ADDENDUM NO. 2

WASTEWATER TREATMENT PLANT EXPANSION  
KYLE, TEXAS

CONTRACT DOCUMENTS, DRAWINGS AND TECHNICAL SPECIFICATIONS

YARD PIPING  
ENLARGED PLAN 5

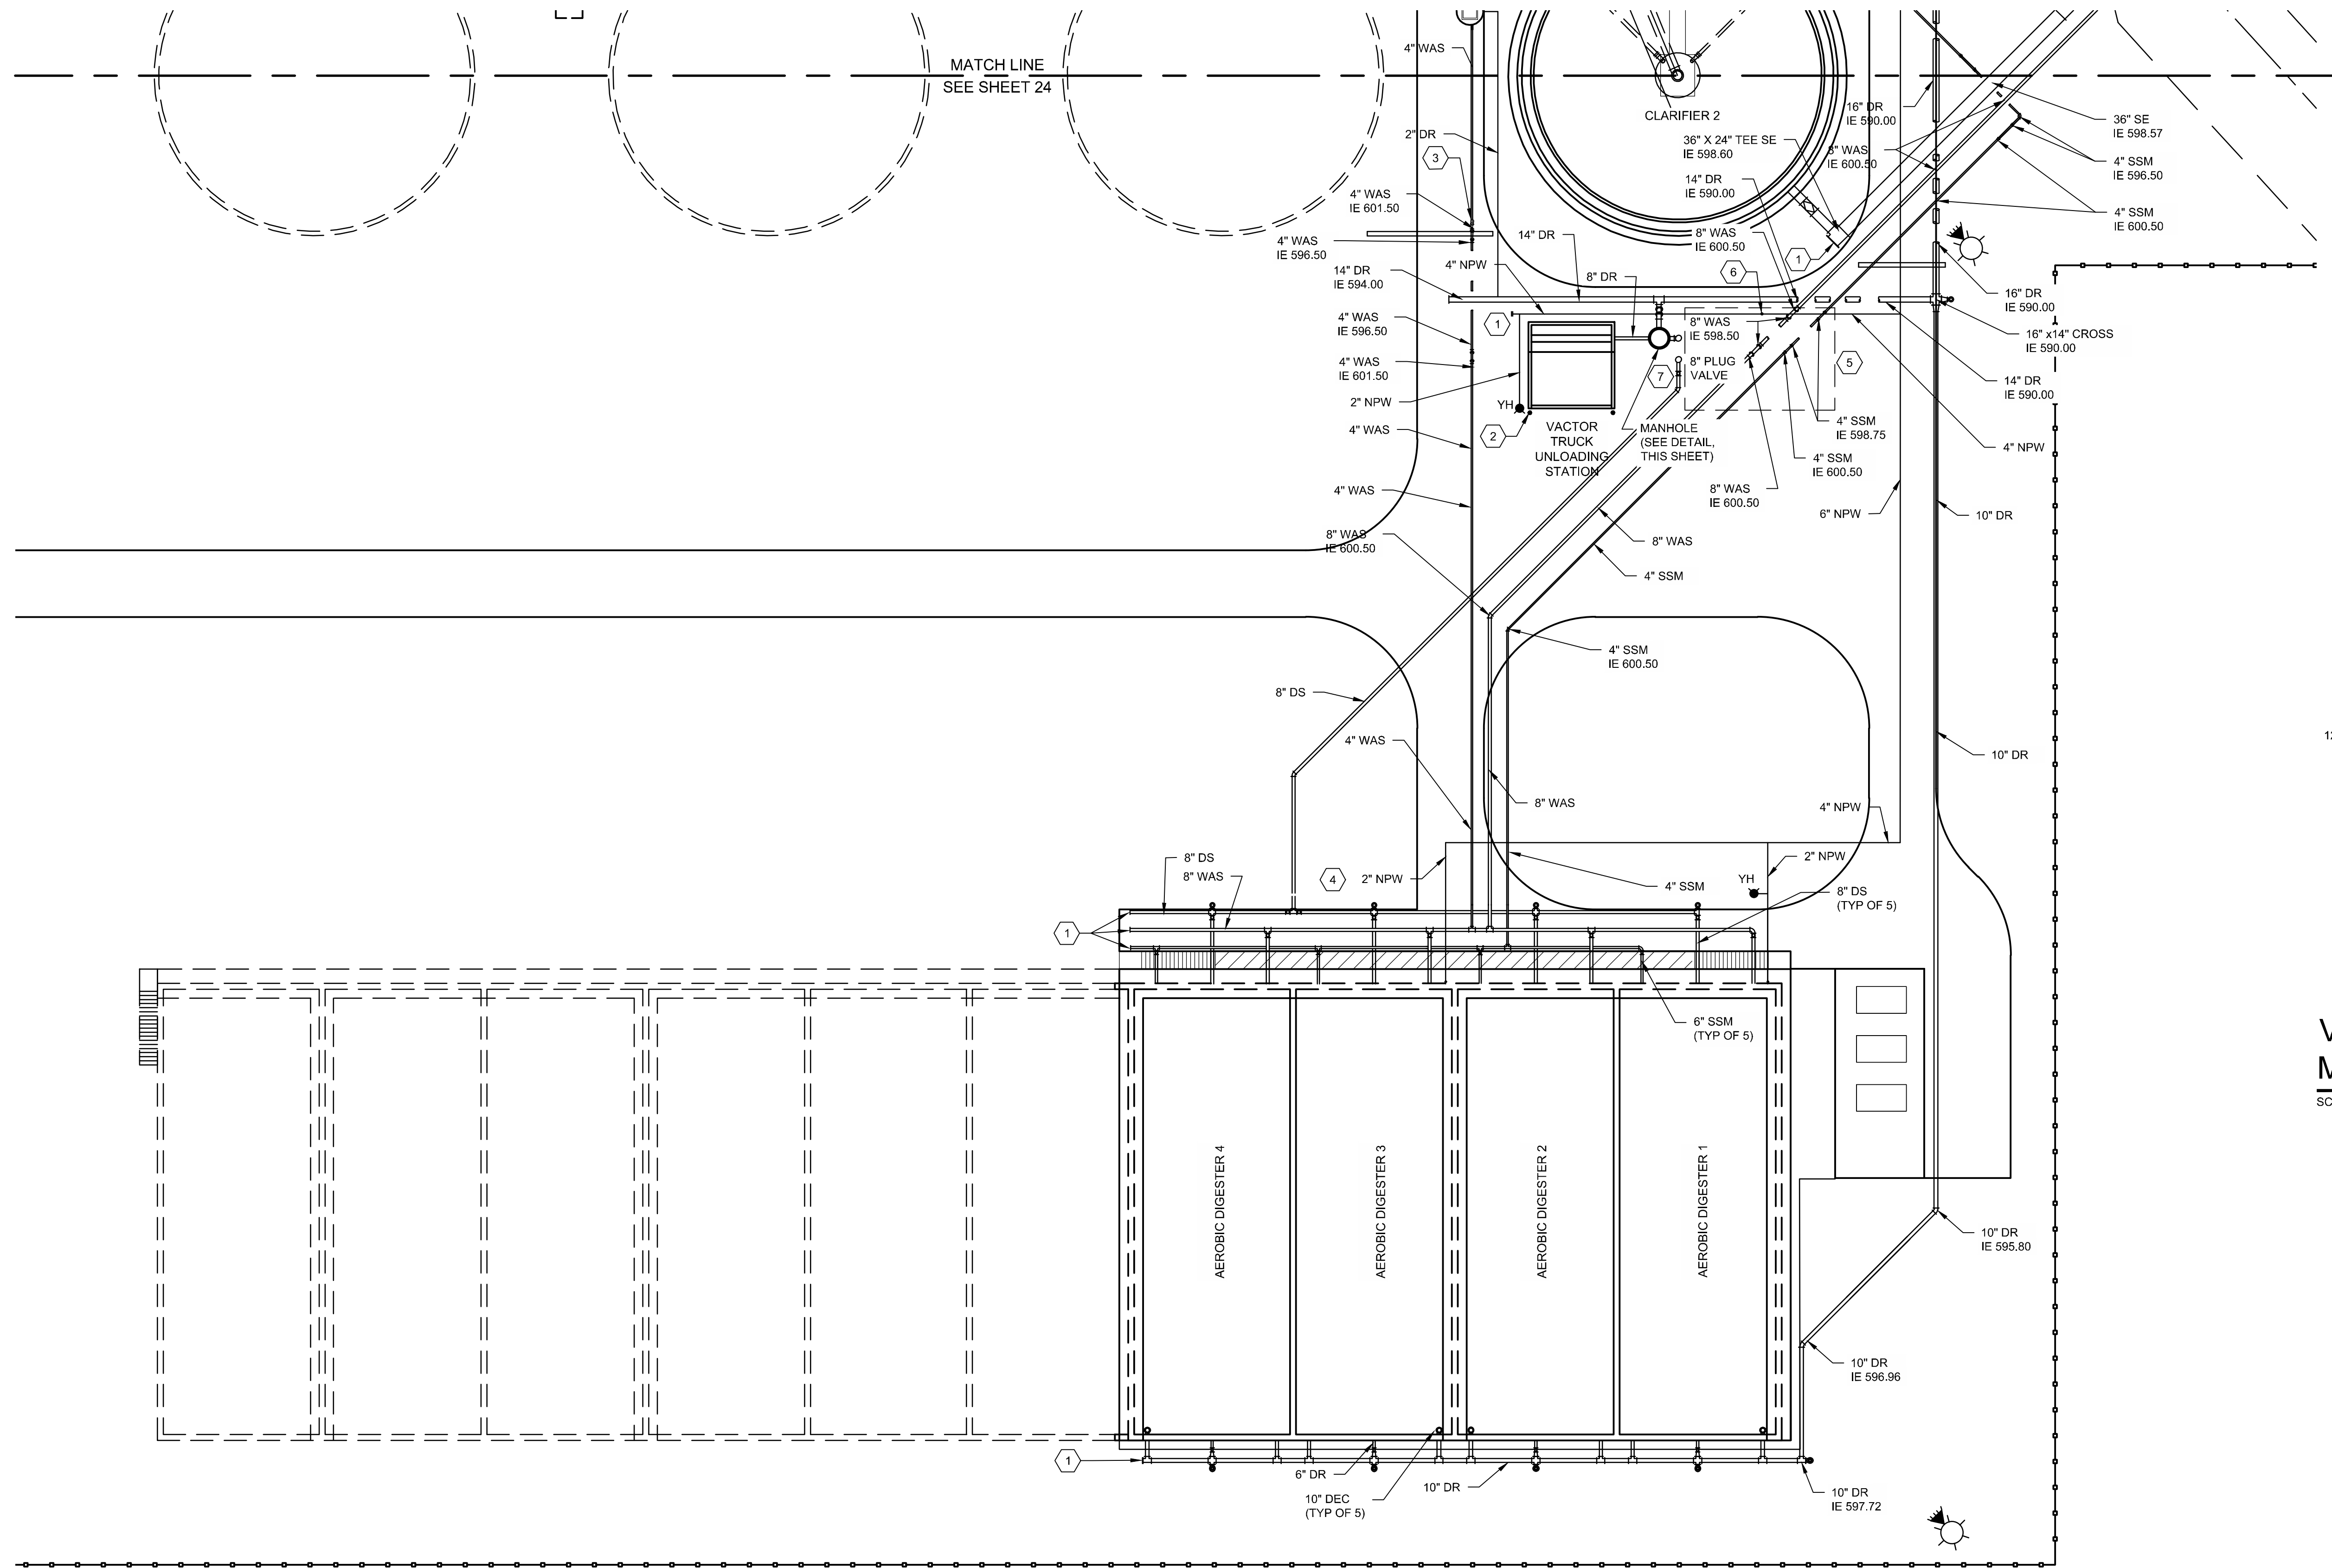
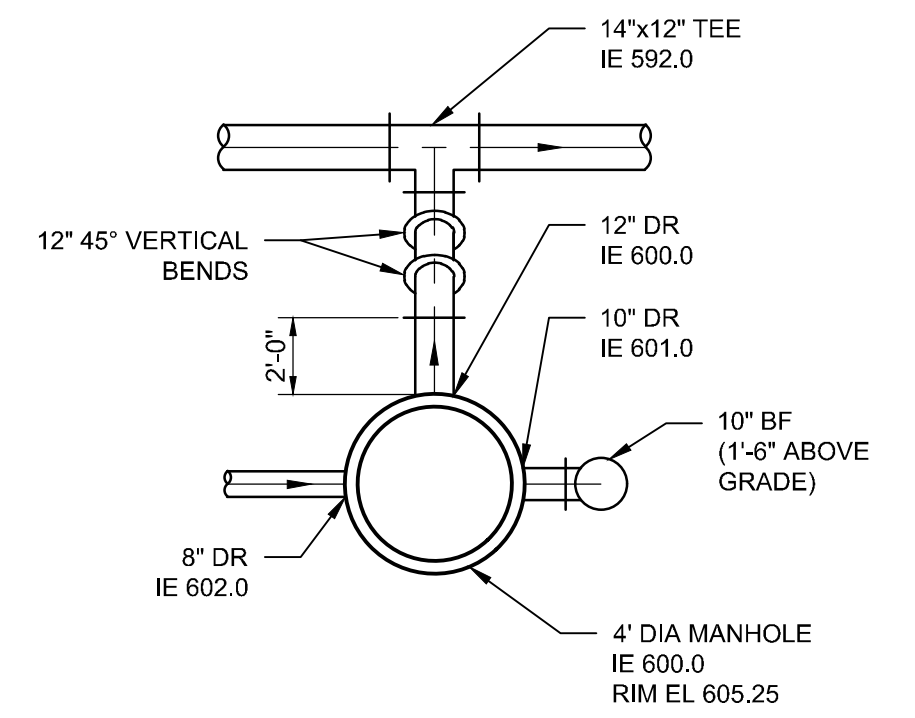
- Answer:** Delete TA designation on Sheet 128, as the Tertiary Building does not have windows.
- 115 **Question:** Looking on drawing - 90 showing the piping layout at the Aerobic Digesters, we notice a 8" SEP pipe shown coming down and connecting to the 8" WAS header pipe. This line is to the left of the 4" WAS pipe. Looking on the yard piping drawing - 26, this pipe does not appear. Please review and clarify this 8" SEP line.

- 116 **Question:** Looking on drawing - 90, we see the 8" DS line coming out from the digester structure and connecting to an 8" DS header pipe. We see two locations where the DS line extends out to the north. There are two 8" plug valves at the MJ tee fittings where the line is shown going out to the north. Then looking on the yard piping sheet - 26 of this area, we see one pipe stubbed out to the north, between Aerobic Digesters No - 3 4. The line does not appear to go anywhere. Please review and clarify the piping configuration for this DS piping and where it should extend.

- Answer:**            The well, torque, and gear requests are acceptable for this project.
- 156      **Question:**      Looking on drawing - 94, showing the Vactor Truck Unloading Station, we notice a YH shown at the south west corner of the structure. There is a 2" NPW pipe extending away at an angle to the south east. Key note # 1 indicates to see the yard piping for continuation of the line. Looking on sheet - 26, we see the Vactor Unloading Station but we do not see a NPW water line going to the station. Please review and clarify where the NPW water line should be routed for this YH.

- Answer:** On Sheet 90, delete the 8" SEP piping and tee interconnected with the 8" WAS header. **See revised Sheets 26 and 90, issued as part of this addendum.**

- Answer:** On Sheet 90, cap the east 8" DS line with a restrained plug. For the west 8" DS line shown on Sheet 90 and Sheet 26, extend the line to the dashed area reserved for dewatering equipment (Coded Note 5). Terminate this 8" DS line with a buried plug valve and flange 12" above grade. **See revised Sheets 26 and 90, issued as part of this addendum.**

- Answer:**            See revised Sheet 26 (with extended NPW serving vactor station yard hydrant on Sheet 94), issued as part of this addendum.

**CHANNEL LEVEL PLAN**  
3/16"=1'-0"

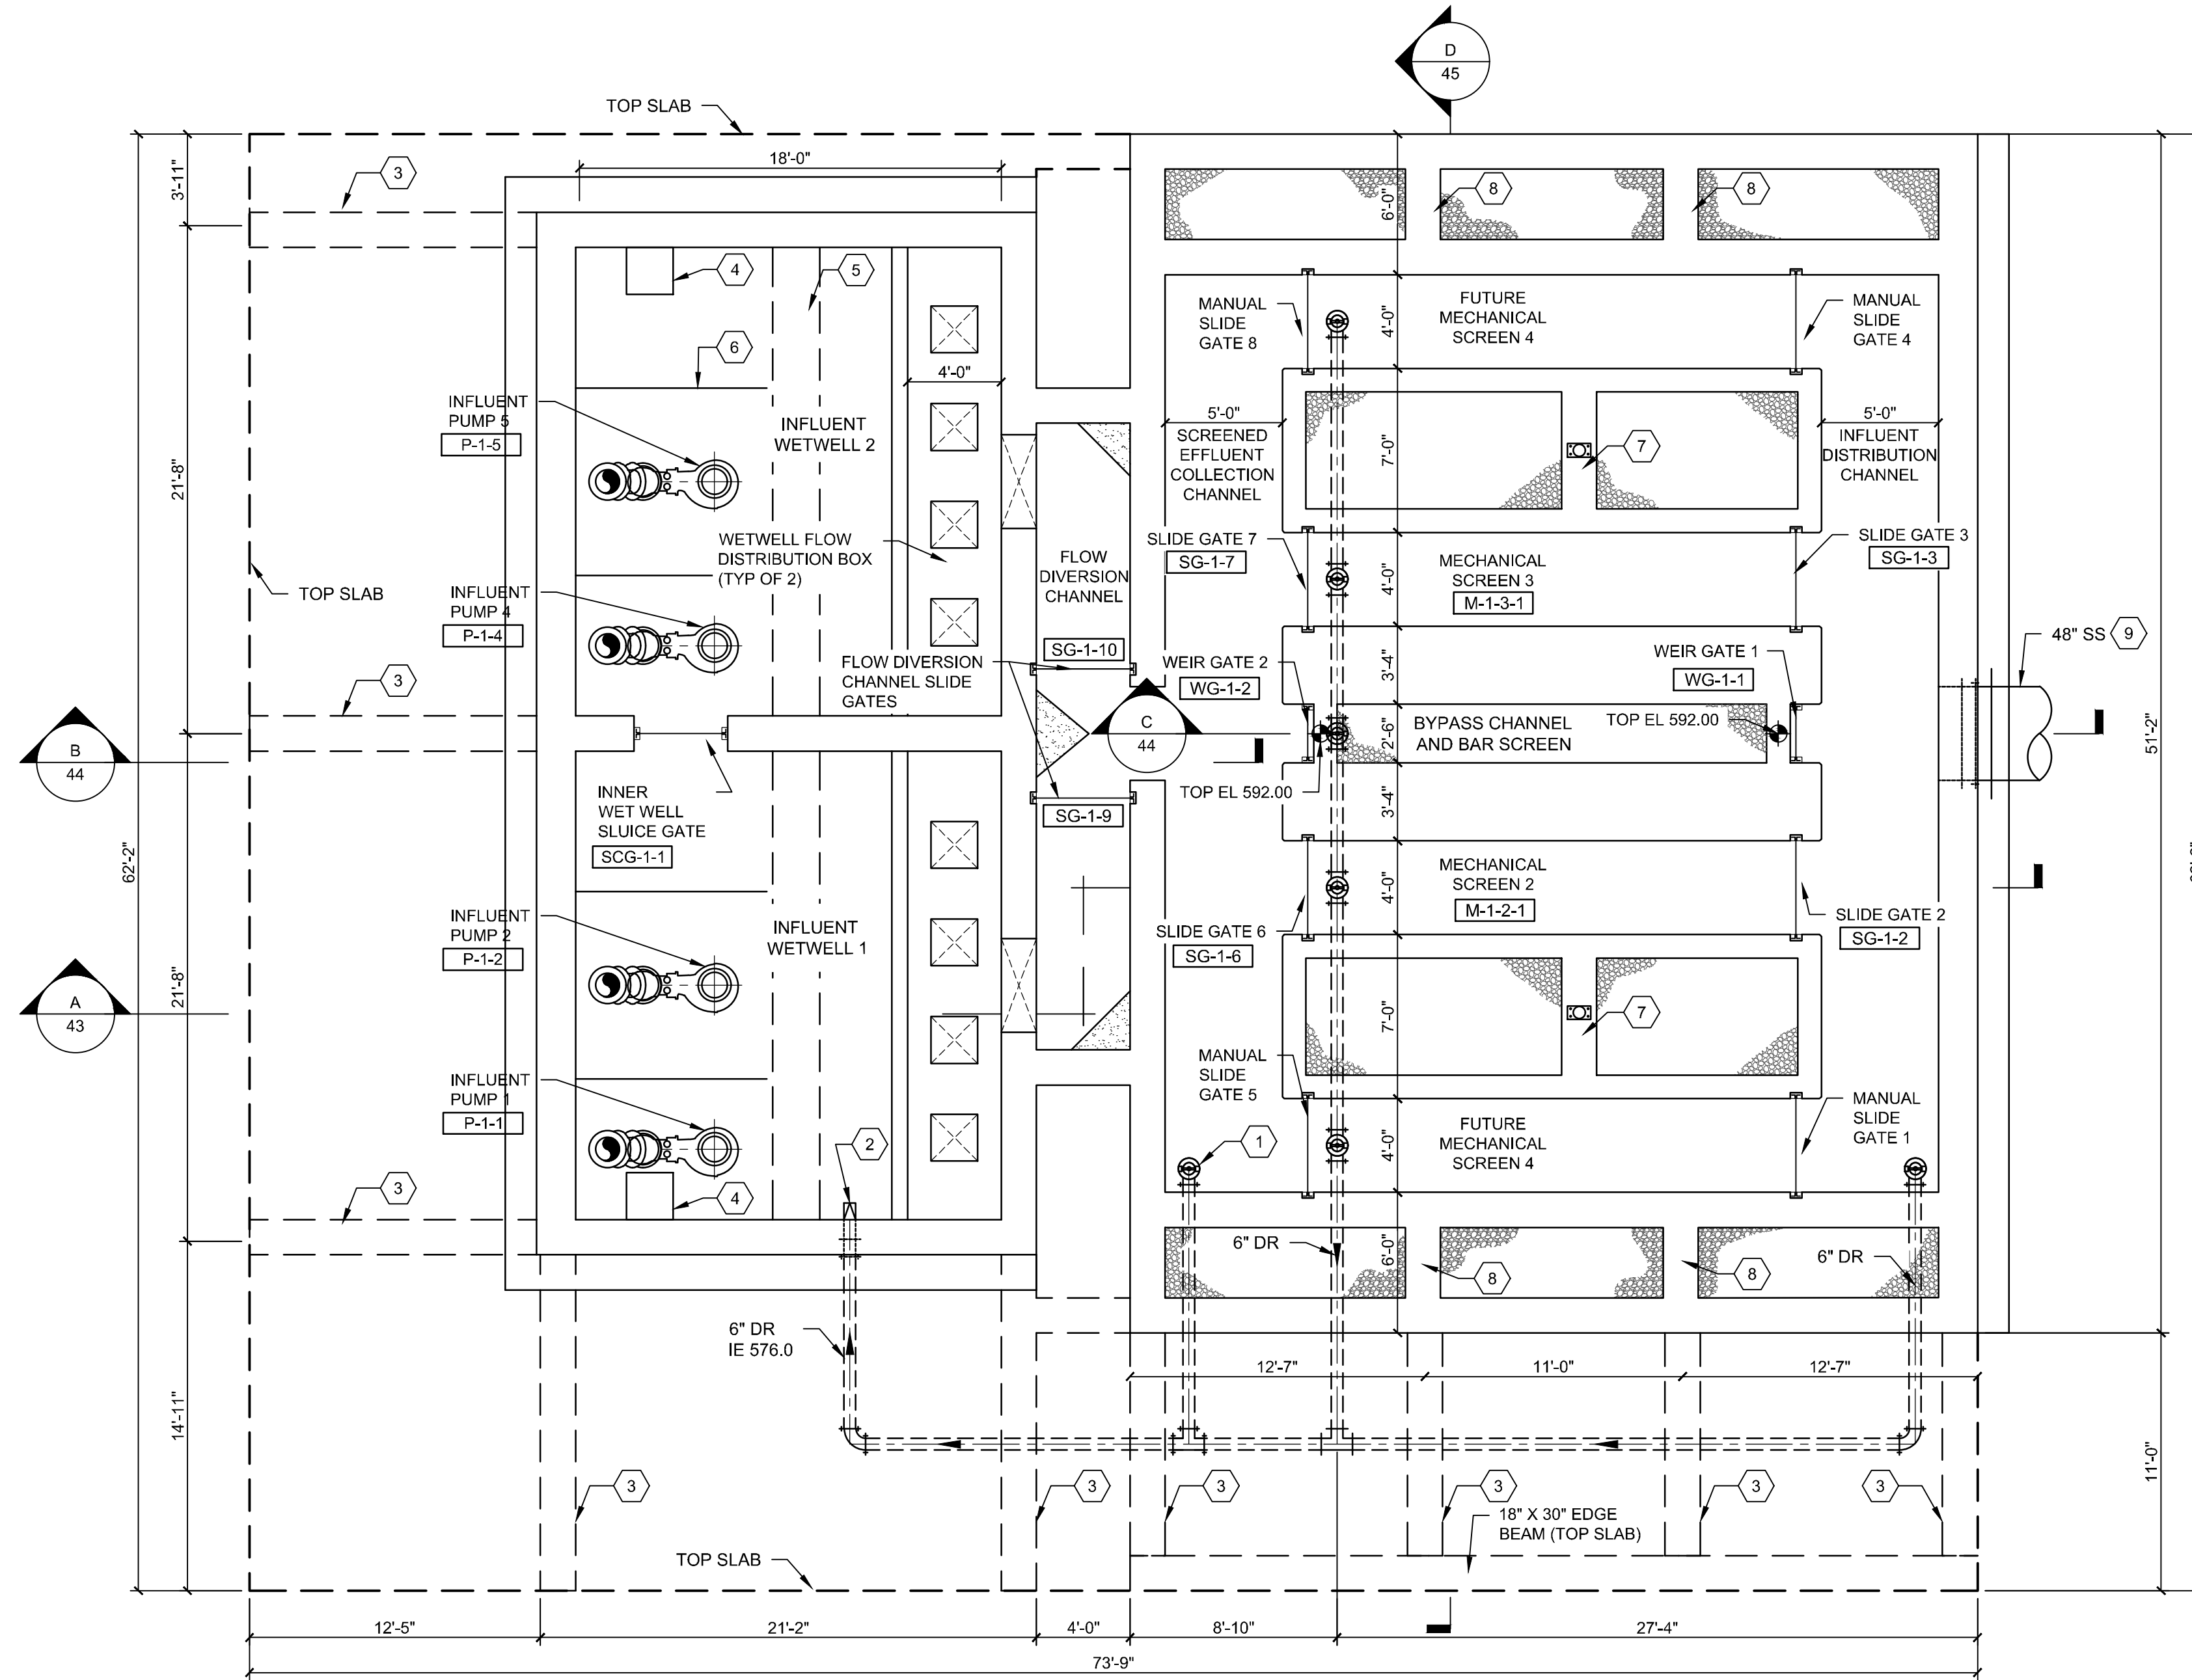
- 121      **Question:**      On Sheet 41 note 7 indicates a 12" Intermediate Bracing Wall. On Sheet 33 it shows that as being a 1'6" wall. Which is correct, and could you provide a cross section?

- Answer:**              Provide intermediate bracing walls 18" throughout, as indicated on revised Sheet 41, issued as part of this addendum.
- 122      **Question:**      Are fire extinguishers required at the Operations Building?
